**EXT. VIEW OF
DIE AF-5241**

DYNAMIC FASTENER	
PART NAME: DYNA-SPLICE 4.5"	
SIZE C	DRAWING NO.: DYNA SPLICE 4.5IN
	REV. 1
DO NOT SCALE DRAWING SHEET 1 OF 1

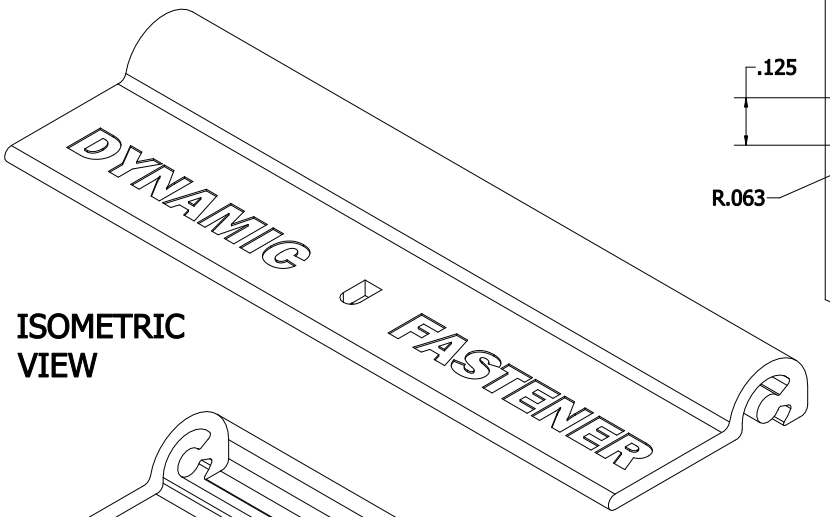
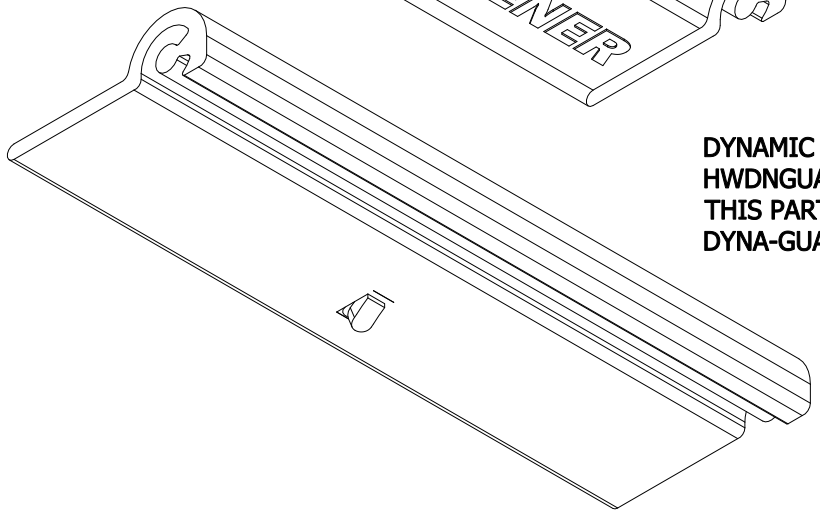
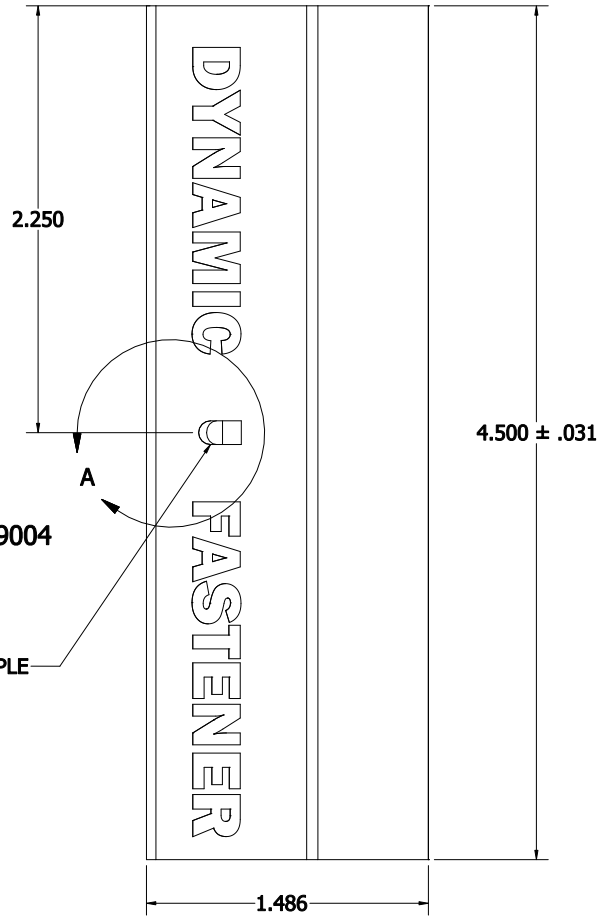
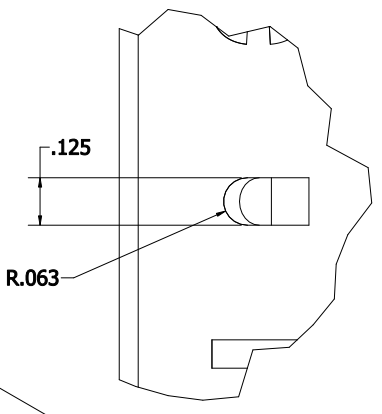
2		1	
REV	DESCRIPTION	ECN #	MFG APPROVED BY
1	DIM. 1.486 WAS 1.433 PER CUSTOMER	101891	KEVIN P.
			DATE
			9/11/2018
